## CATALOG PRODUCT NOTIFICATION

Date:	February 28, 2017		
Customer Part Number:	732-3139-5-ND, 732-3145-5- ND, 732-3144-5-ND, 732- 3143-5-ND, 732-3141-5-ND	Wurth Electronics Midcom Part Number:	744862018, 744862250, 744862180, 744862120, 744862056
Customer Name:	digi-key	Wurth Electronics Midcom Inside Sales Rep:	
<b>Customer Contact</b> :

Product/Process Change

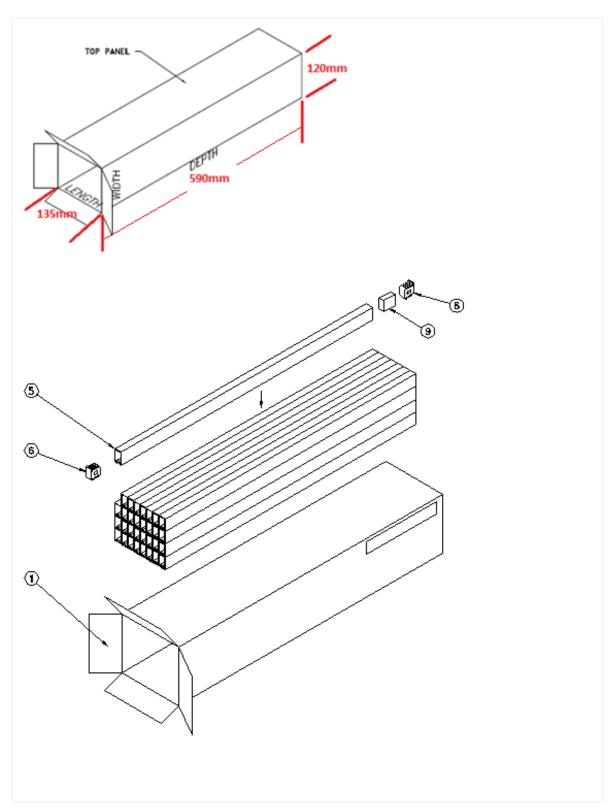
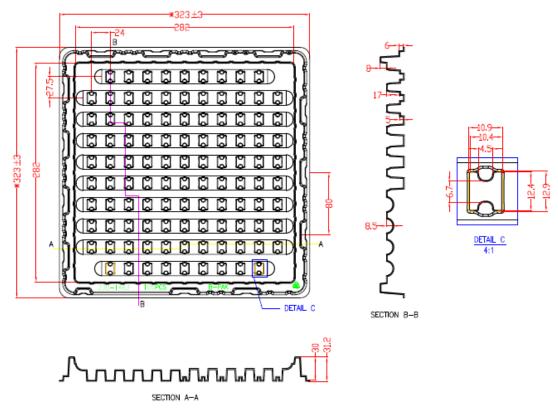
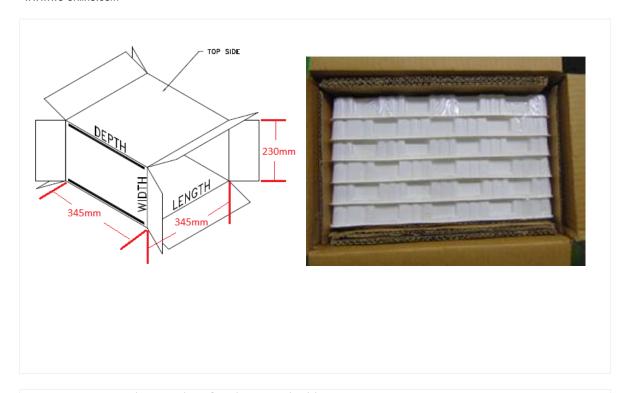
Change packaging method and quantity to prevent core crack quality issue in transportation process and better protect goods.

From current tube packaging, TQ: 30pcs/tube, BQ: 960pcs/box.

To prevent the core crack issue in transportation process and offer better protection. Package quantity will change from Tube Qty. 30pcs/tube, Box Qty.: 960pcs/box to Tray Qty.: 106pcs/tray, Box Qty.: 636pcs/box.

Outer carton size will change from: L135mm x W120mm x D590mm to: L345mm x W230mm x D345mm
